Company	Trenz Electronic GmbH
PCN Number	PCN-20200330
Title	TE0630-02 SPI Flash Change
Subject	BOM change
Issue Date	2020-04-06

This change affects all Trenz Electronic TE0630 SoMs of revision 02: TE0630-02*.

Locate Flash (U14) on bottom side of PCB:

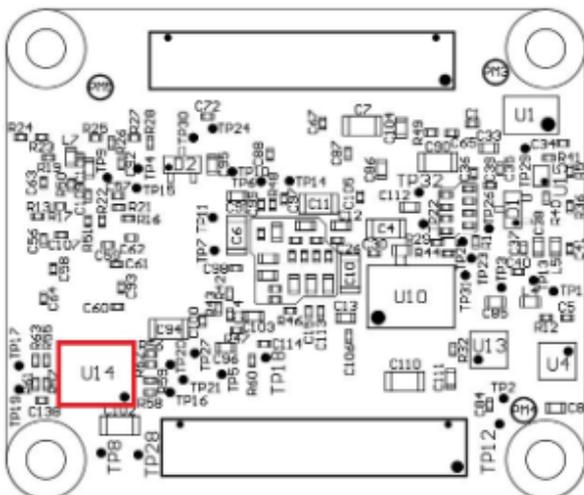
#1 Change SPI Flash from W25Q64FVZPIG to W25Q64JVZPIQ

Type: BOM Change

Reason: W25Q64FVZPIG SPI Flash is obsolete.

Impact: None. Both have same JEDEC ID 9Fh and manufacturer ID 90h.

old	new
W25Q64FVZPIG	W25Q64JVZPIQ

Changed versions will be shipped from June 2020 after old stock is gone. Modules with serial number greater than 639820 are assembled with the new flash.
